Assembly Alert: 185

Subject: Aileron Cable/Wing Truss Clearance

Models Affected: All 141 wings under construction.

RRRMS S-21 OUTBOUND
141 WING - AILERON CABLE CLEARANCE MODIFICATION

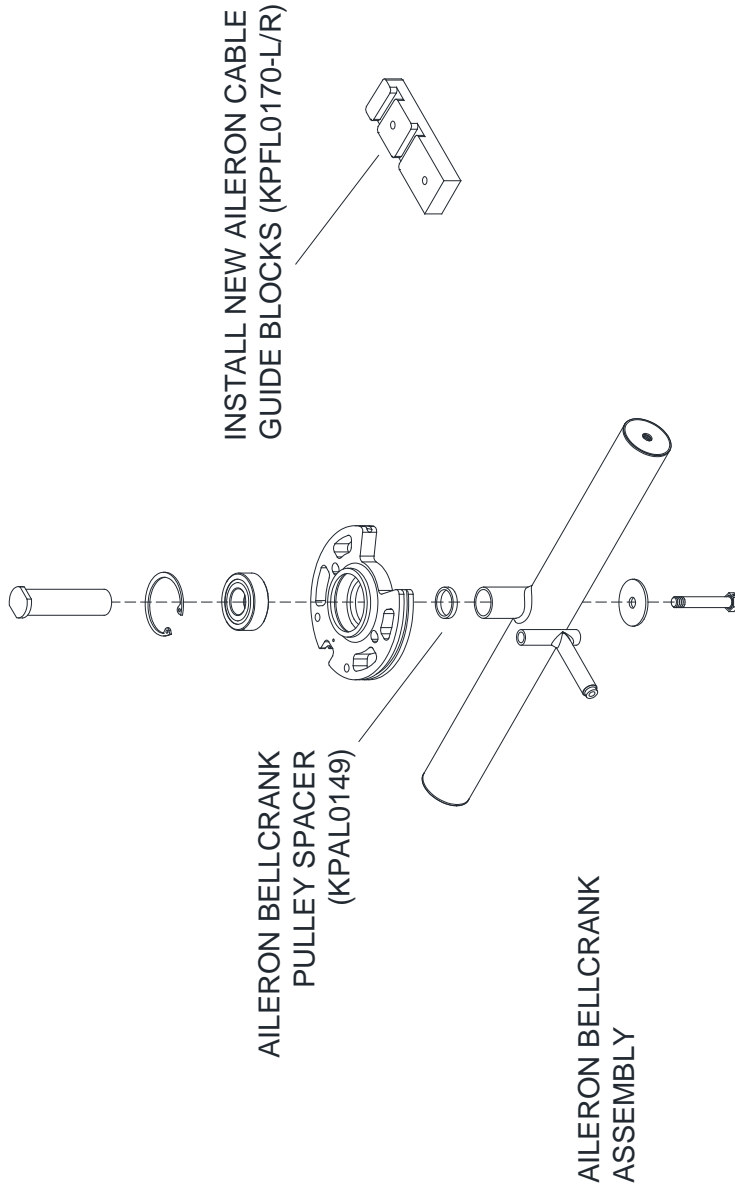
There is a clearance issue between the aileron cables and the wing truss. To increase the clearance, install the Aileron Bellcrank Pulley Spacer (KPAL0149) between the aileron bellcrank and mount as shown in the figure below.

Replace the aileron cable guide blocks (KPFL0170 L/R). The new blocks route the cables differently to allow more clearance to the wing truss.

This may bring the aileron cables close to the top of the hole in the wing rib nearest the aileron bellcrank. If this clearance is less than .125", use a half round file to file the rib and achieve .125" of clearance.

AILERON BELLCRANK PULLEY SPACER PROVIDED
INSTALL AS SHOWN BELOW
